Access Compliance Report Public Rights-of-Way (RR Crossings)

Intersection ID: 8157	Main Street: N_TRYON_ST	Location: N/A
ADA ID: 156456E3BDC4	Overall Compliance: No	Severity Score: 0.0
Codes/Mitigation Info/Possible Solution		Field Measurements/Component Compliance

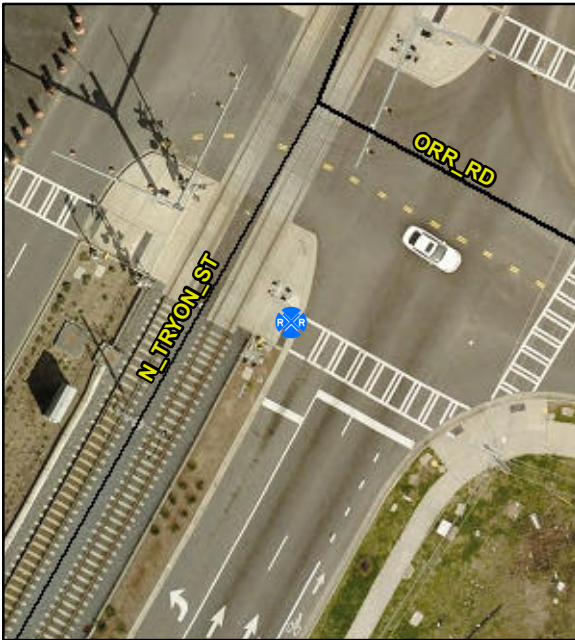
Compliance	Description	Data
Yes	DWS Provided?	Yes
Yes	DWS Contrast?	Yes
Yes	DWS Width (in)	Yes
Yes	DWS Length (in)	24.0
Yes	DWS Offset (in)	145.0
No	Pedestrian Gate?	No
N/A	DWS Outside Gate?	No
N/A	Rail Type?	LightRail
No	Flangeway Gap (in)	26.0
Yes	Sidewalk Width (in)	120.0

Remove & Replace Detectable Warning System. Provide Pedestrian Gate. Remove & Replace Walking Surface Adjacent to Rail.
